**NOTICE OF ADDENDUM  
ADDENDUM 1**

**CONTRACT NO. 9168**

# CAPITAL SQUARE NORTH (CSN) - LEVEL 2 PLAN

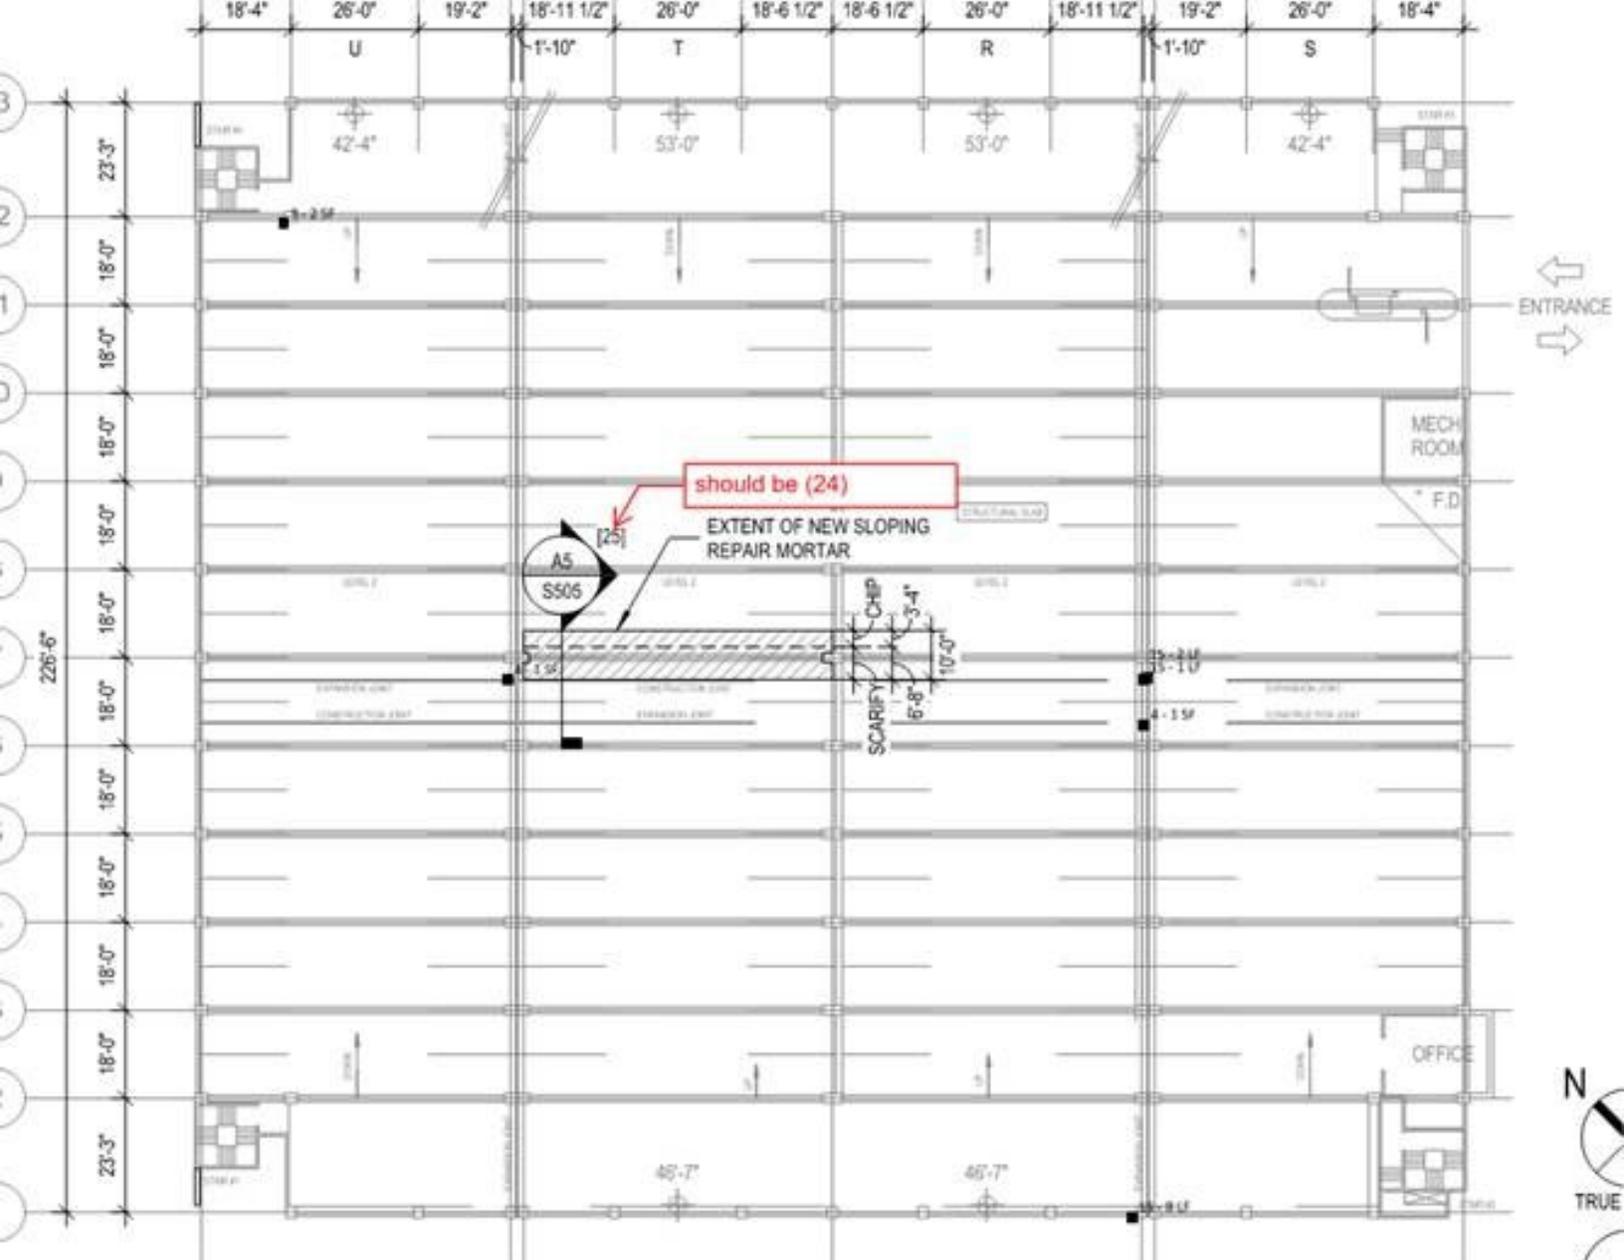
The reference for Detail A5 on sheet CN-2102 should be 24, not 25.
